Medworth Energy from Waste Combined Heat and Power Facility

PINS ref. EN010110
Document Reference Vol 9.2
Revision: 1
Deadline: 1
March 2023

Applicant's response to the Relevant Representations – Part 9 Appendices

Figure 2.1 – HGV Movements Over Construction Programme

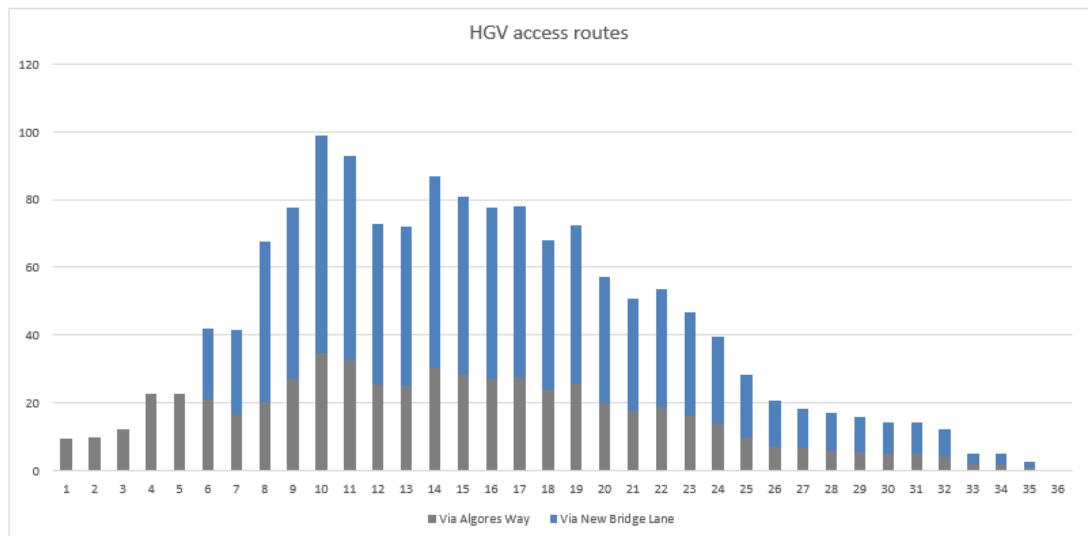
- 1.1.1 Cambridgeshire County Council (CCC), jointly with Fenland District Council, submitted relevant representation (RR-002) to the Planning Inspectorate (PINS) as part of the examination phase of the Medworth Energy from Waste (EfW) Combined Heat and Power (CHP) Facility Development Consent Order (DCO) Application. The DCO Application was submitted by Medworth CHP Ltd (the Applicant).
- 1.1.2 A meeting was held on 24 November 2022 between the Applicant and its environmental consultants (WSP) and representatives from CCC in order to discuss the comments provided and clarify questions concerning **Chapter 6: Traffic and Transport** of the Environmental Statement (ES) (**Volume 6.2**) [APP-033].
- 1.1.3 This Technical Note provides a response to CCC'S request for clarification with regard to the number of HGVs proposed to use Algores Way during the construction phase.

- 2.2.2 Month 14 represents the peak month for total construction traffic, however, the peak for Algores Way would be month 10 which would result in 35 HGVs per day, (70 two-way vehicle movements). Accounting for the removal of existing HGV traffic associated with the existing operational WTS, the net increase in HGV/LGV traffic in months 10 and 14 would therefore be 12 and 2 two-way movements respectively. With the construction site operating 12 hours weekdays this could then equate to an additional 1 two-way movement.

- 2.2.3 **Figure 2.1** provides a summary of HGV movements on Algores Way and New Bridge Lane during the construction programme.
